Memo

Date: April 8, 2010
To: City Manager
From: Community Sustainability Division
File No: Z07-0070 **Applicant:** Protech Consultants Ltd.
At: 455 Cavell Pl **Owners:** Sundowner Holdings Ltd. & Woodlawn Projects Inc.
Purpose: Supplemental Report - To rezone a portion of the subject property from the A1 - Agriculture 1 zone to the RU1h - Large Lot Housing (Hillside Area) zone to facilitate a residential subdivision.

Memo

File No: Z07-0070

THE CITY OF KELOWNA
 ENGINEERING DIVISION
 CABEL PLACE - PHASE II
 LOT GRADING PLAN
 EROSION & SEDIMENTATION CONTROL PLAN

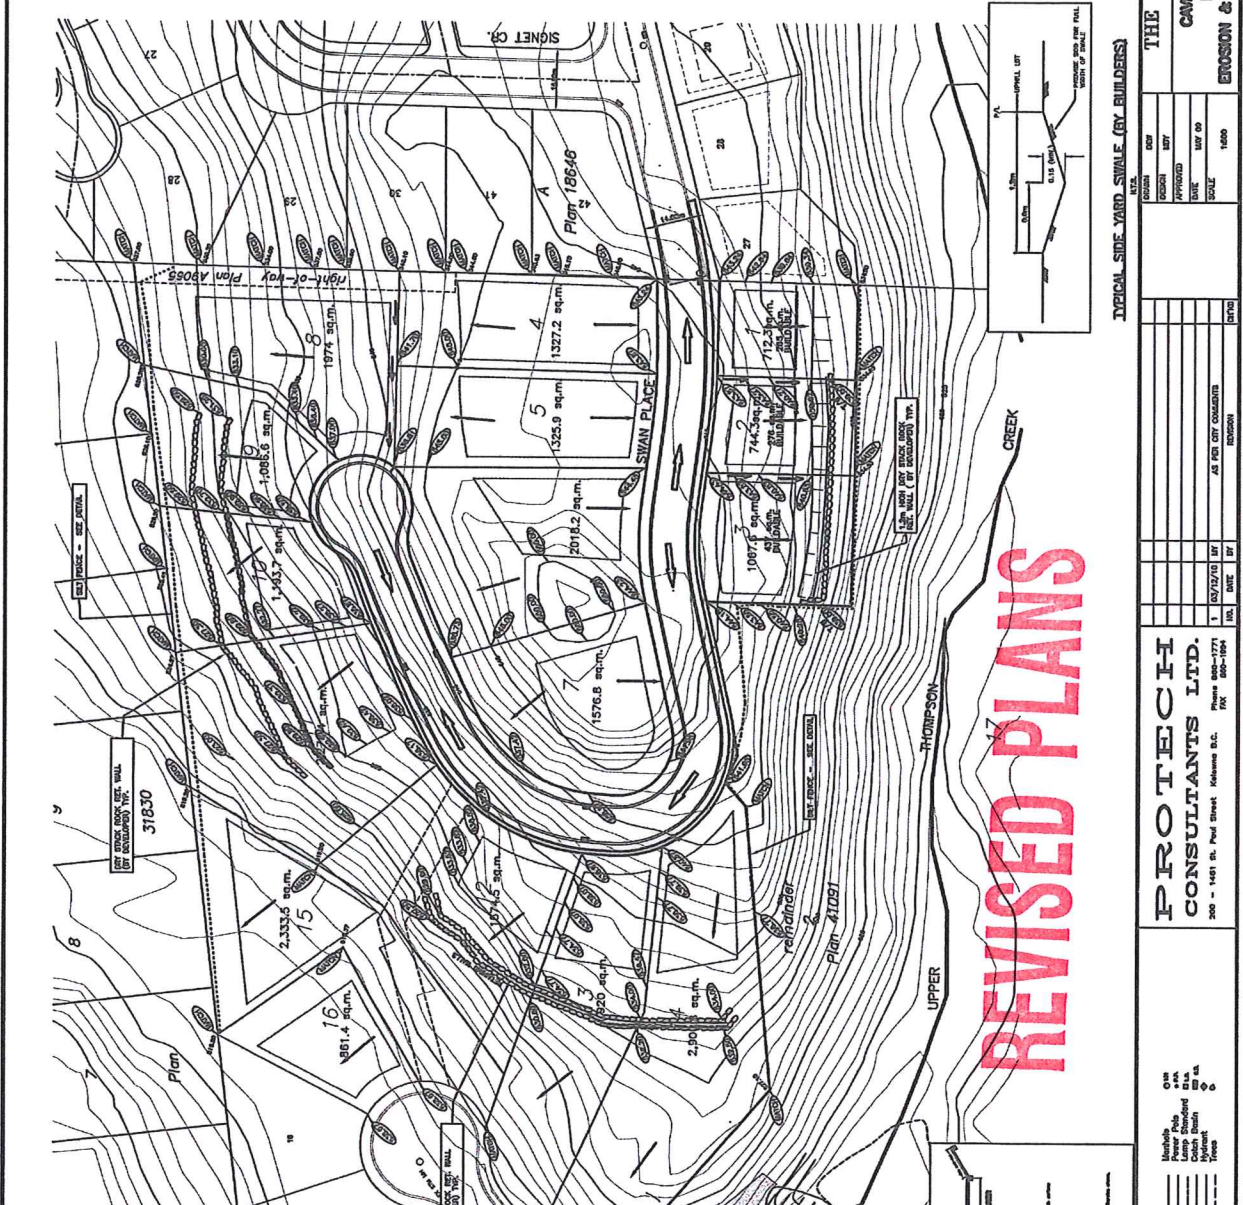
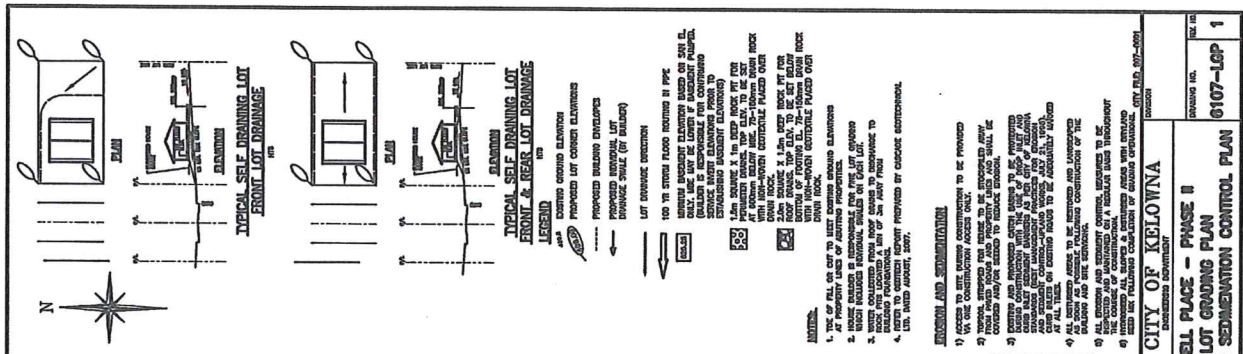
- b) Provide the following drawings:
 - i) A detailed Lot Grading Plan (indicate on the Lot Grading Plan any slopes that are steeper than 30% and areas that have greater than 1.0 m of fill);

- ii) A detailed Stormwater Management Plan for this subdivision; and,
 - iii) An Erosion and Sediment Control Plan.
- c) Show details of dedications, rights-of-way, setbacks and non-disturbance areas on the lot Grading Plan.

MAP "A"

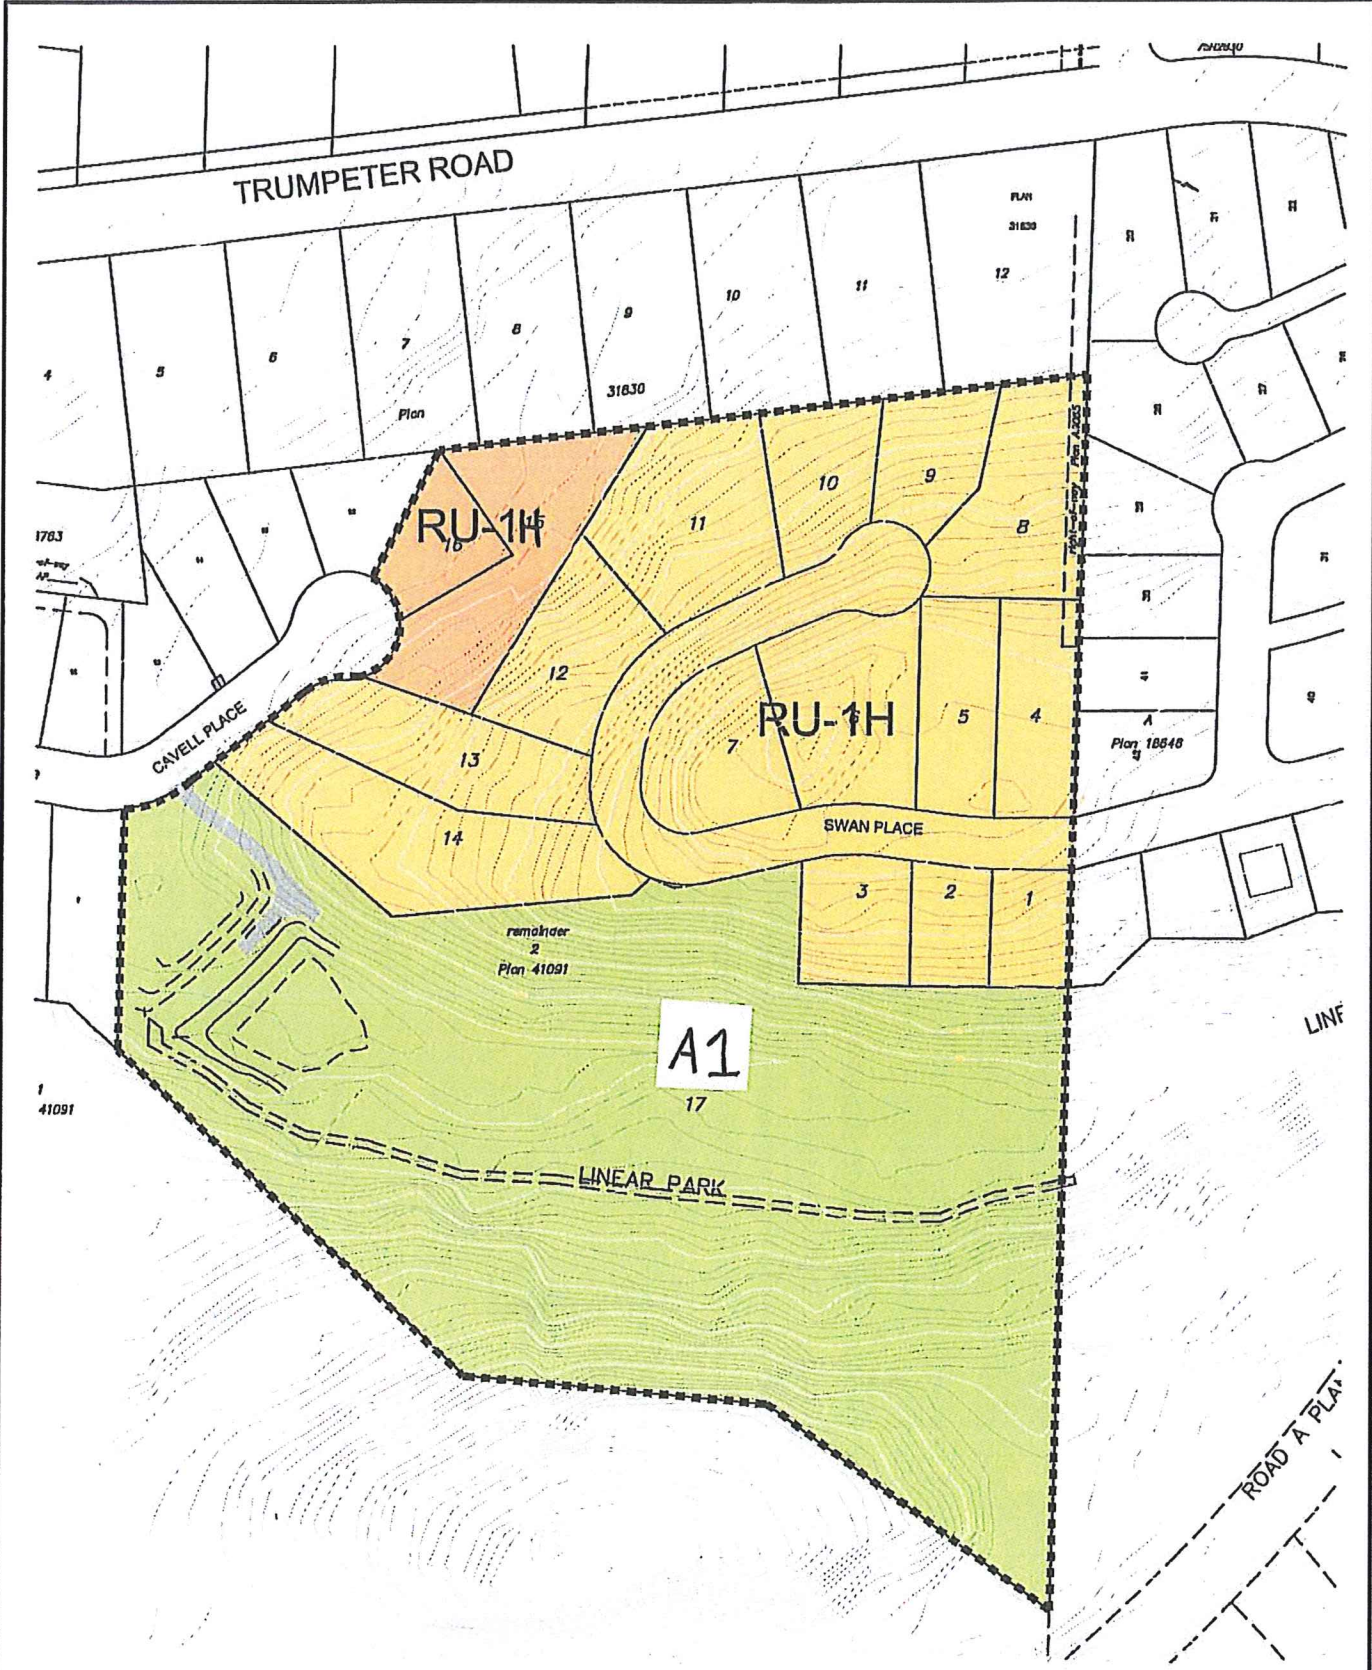
It is commendable that the applicant will dedicate the remainder of the site, which is either in excess of 30% slope or identified as wetland/stream, for preservation as a linear park. This area shown as A1 on the attached "Proposed Rezoning Plan" map, will be zoned at a later date to P3 - Parks & Open Space with a concurrent OCP amendment application.
